CHANGE ORDER CONSTRUCTION PROJECTS

Project Name: Willow Ave. and Alhambra Ave. Drainage Improvements

CHANGE ORDER NO. 3

ADD 48'X76" ERCP FROM VIRGINIA DR TO WILLOW AVE.

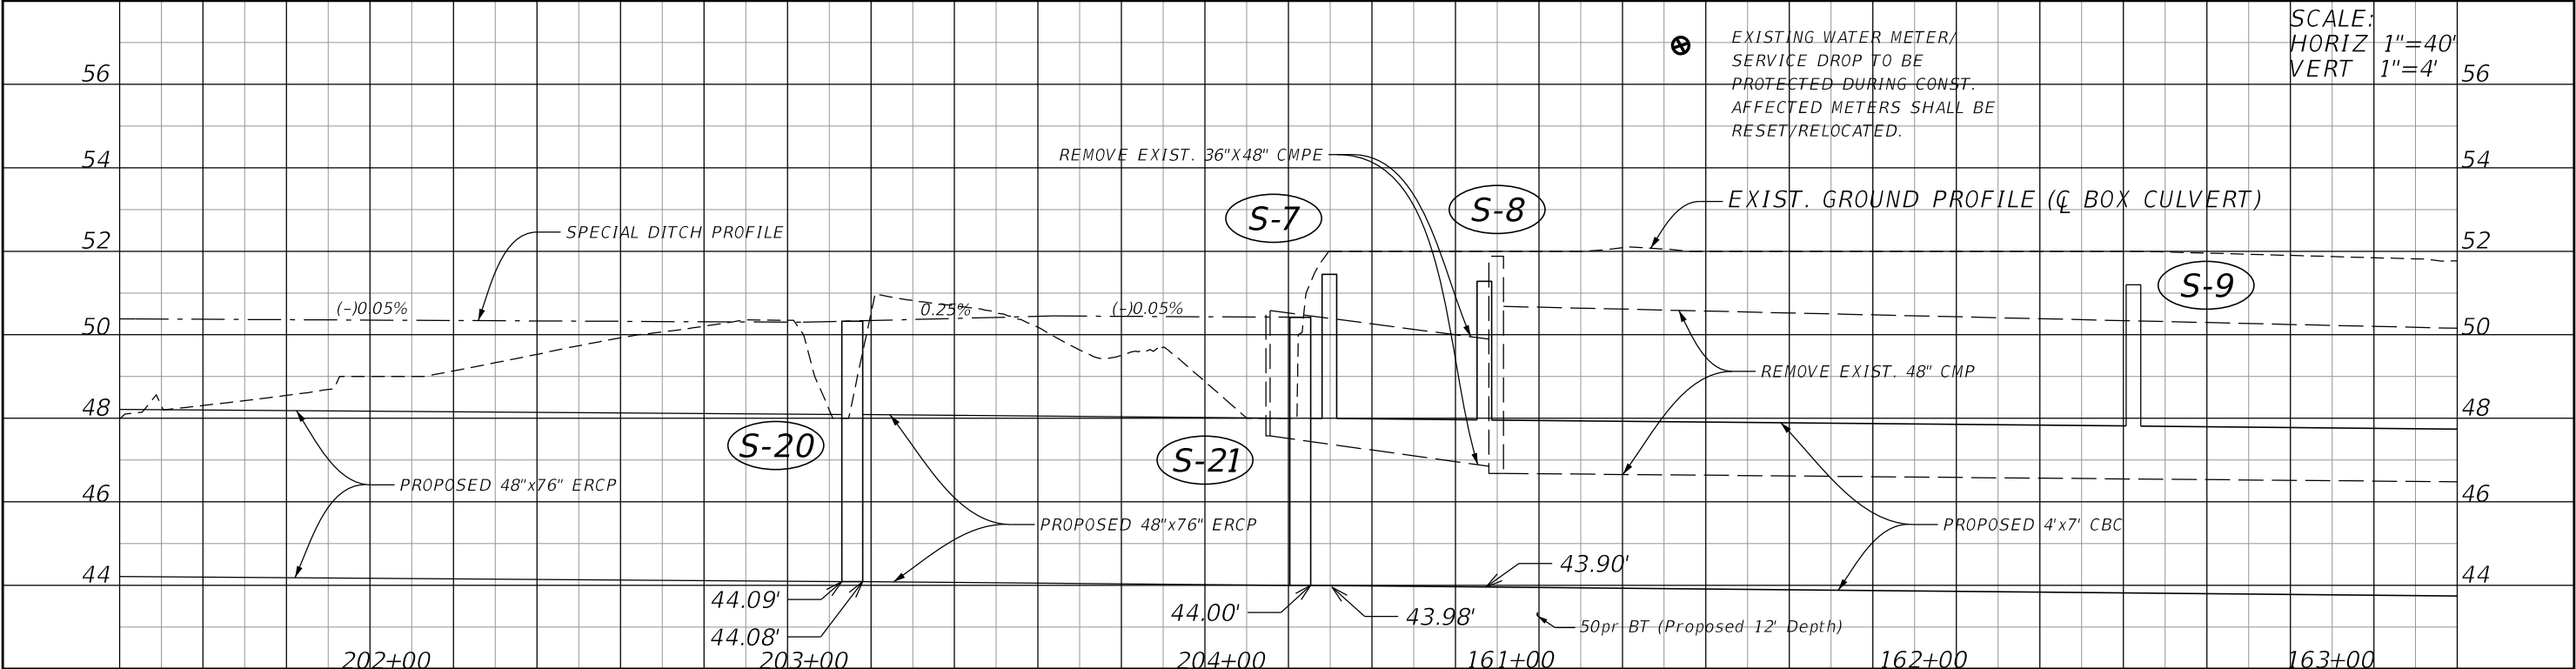
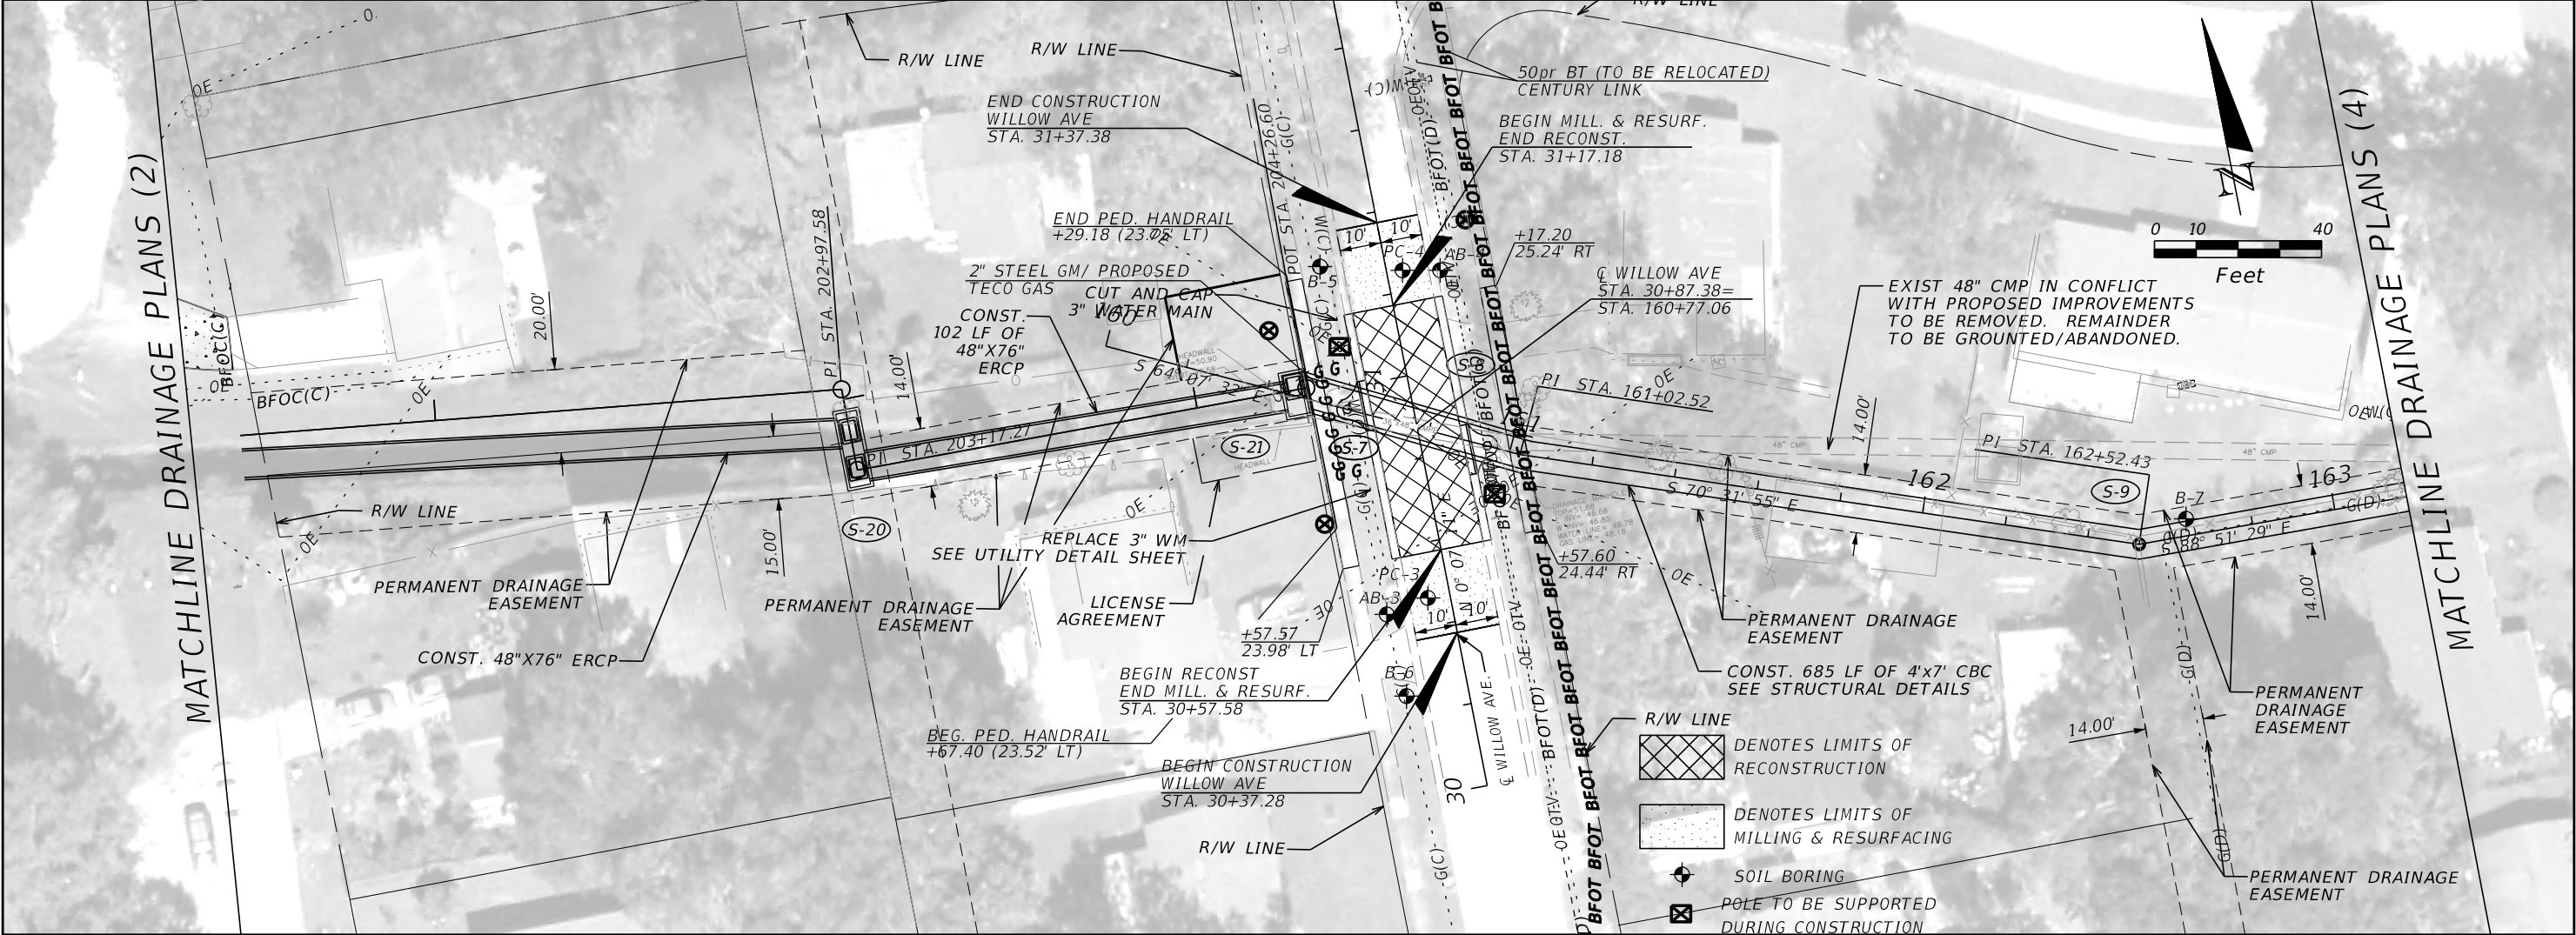
Add 396 Lf of 48" x 76" ERCP between previously installed concrete box culvert from Virginia Dr. to Willow Ave.

Item #	Item Description	Cost
1.0	Install of 48"x76" elliptical RCP from the Virginia box culverts to the Willow box culverts per the plans provided on 08/19/25. This also includes site restoration, utility adjustments, and other miscellaneous scopes necessary for this install. This would also include 65 contract days.	\$767,929.27
TOTAL COST FOR CHANGE ORDER		\$767,929.27
